TITLE : AIR CONDITIONING - PRESSURIZATION CONTROL - MODIFICATION OF PIN
PROGRAMMING TO DISABLE USE OF EXTERNAL MODE (RETRO SOLUTION)

MODIFICATION No. : 32221K7821

SERVICE BULLETIN No. : A320-21-1138

Figure 1 Sheet 1
 Modification of the Wiring in 90VU

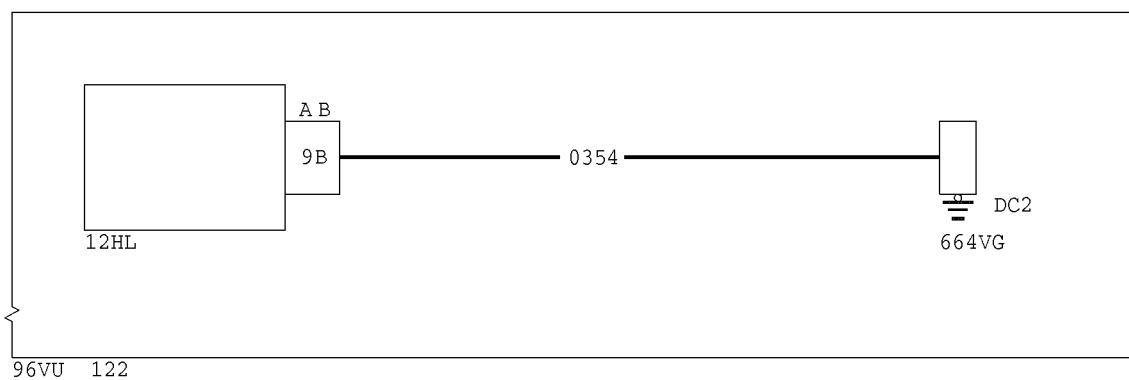
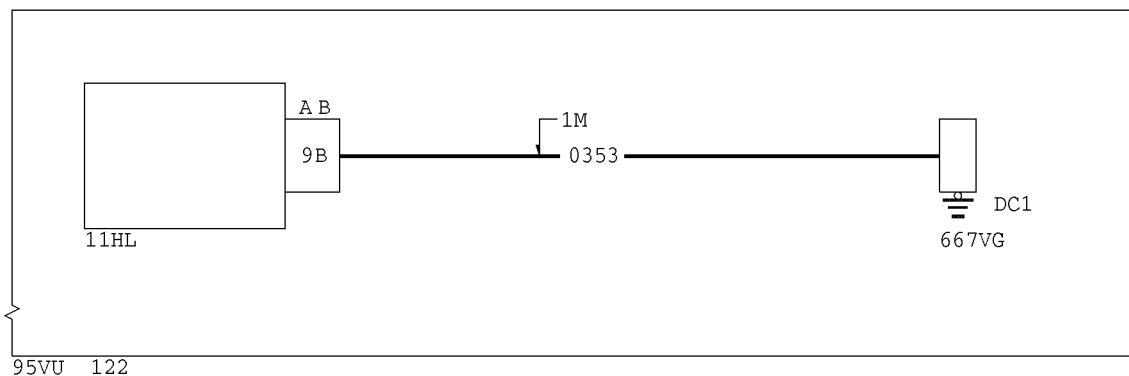
- (1) Modify the wiring in the shelf 95VU.
Refer to Figure 1
Refer to Figure 2

- (f) On the electronics rack 90VU, remove and retain the shelf 95VU and its fasteners.
- (g) Install the wire shown on the line 1, refer to Figure 2 , supplied in :

- (f) On the electronics rack 90VU, remove and retain the shelf 96VU and its fasteners.
- (g) Install the wire shown on the line 2, refer to Figure 2 ,
supplied in :

— NEW WIRE

NOTE : UNLESS OTHERWISE SPECIFIED PREFIX ALL WIRE IDENTIFICATION WITH ATA2131
 UNLESS OTHERWISE SPECIFIED ALL WIRES ARE CF22 GAUGE
 UNLESS OTHERWISE SPECIFIED ALL ROUTES ARE 2M
